Date: May 19, 2022  
Serial: RA-22-0144

H. B. ROBINSON STEAM ELECTRIC PLANT, UNIT NO. 2  
DOCKET NO. 50-261/RENEWED LICENSE NO. DPR-23

Subject: **Response to NRC Request for Additional Information Regarding Supplemental  
Response to Generic Letter 2004-02 (EPID L-2017-LRC-0000)**

**RESPONSE TO NRC REQUEST FOR ADDITIONAL INFORMATION ON THE FINAL  
SUPPLEMENTAL RESPONSE TO NRC GENERIC LETTER 2004-02, "POTENTIAL IMPACT  
OF DEBRIS BLOCKAGE ON EMERGENCY RECIRCULATION DURING DESIGN BASIS  
ACCIDENTS AT PRESSURIZED-WATER REACTORS"**

Figure 5.1-3 - Nukon® and Temp-Mat™ Fibrous Insulation Debris Transport Logic Tree

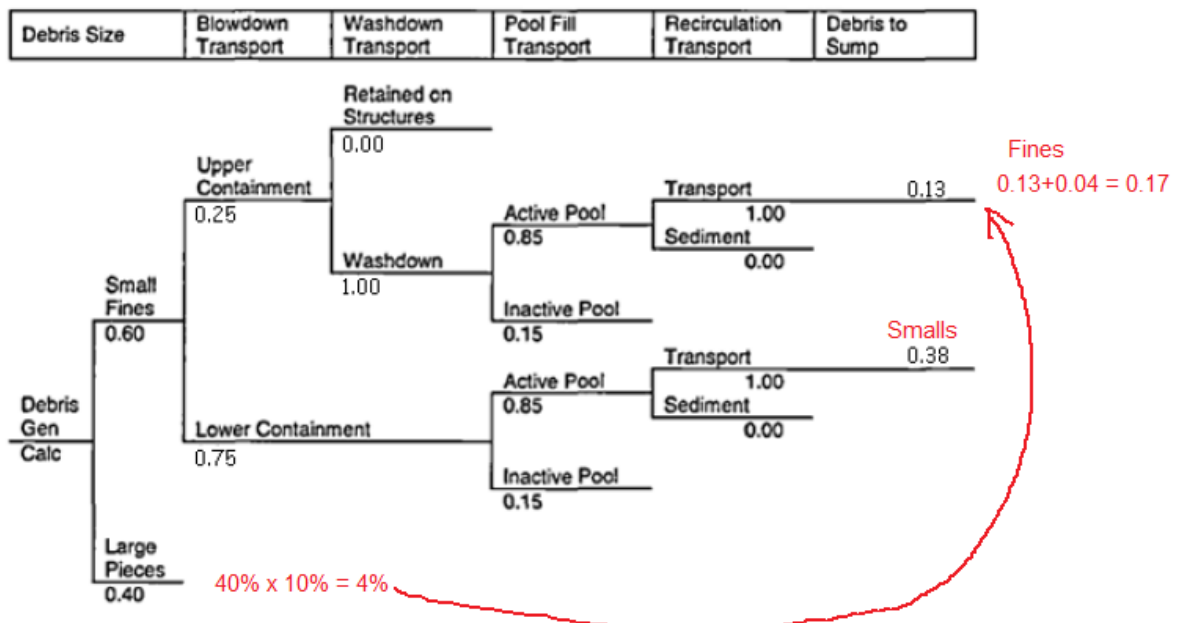
Provide the methodology for calculating the transport fractions provided in the debris table in Section 3.n.1.4 of the final supplemental response.

The logic tree for Nukon® and Temp-Mat™ fibrous insulation debris incorporates the fiber debris size distribution of 60% small debris and 40% large debris, which is from the NEI 04-07 Baseline Methodology and endorsed by the NRC. The 60% fraction for fines includes consideration for fibrous erosion. The overall transport fraction for the small fines is determined by summing the proportions for each of the paths from the zone-of-influence (ZOI) to the ECCS sump. The total Nukon® and TempMat™ fibrous insulation small fines transport fraction is 51%. An additional 10% of large pieces (40% of total) are assumed to deposit on the screens as fines (Ref. 5).

The overall transport fraction for Nukon and Temp-Mat small fines is determined by summing the proportions of each of the paths from the ZOI to the ECCS sump. The total Nukon and Temp-Mat fibrous insulation small fines transport fraction is 51%. An additional 10% of large pieces (40% total) are assumed to deposit on the screens as fines, or 4%, for a total of 55% (Ref. 5, Figure 5.1-3). Per Appendix II, Section II.3.1.1 of the NEI 04-07 Safety Evaluation Report, 75% of fibrous debris designated as “small fines” are assumed to be fibrous “small pieces” or “smalls”, and 25% of the “small fines” are assumed to be “individual fibers” or “fines”.

Based on this, the specific transport fractions of Nukon and Temp-Mat small fines for the penetration test are calculated as follows:

$$\text{Percent "smalls"} = (0.75 \times 0.51) \times 100 = 38\%$$

$$\text{Percent "fines"} = (0.25 \times 0.51 + 0.04) \times 100 = 17\%$$
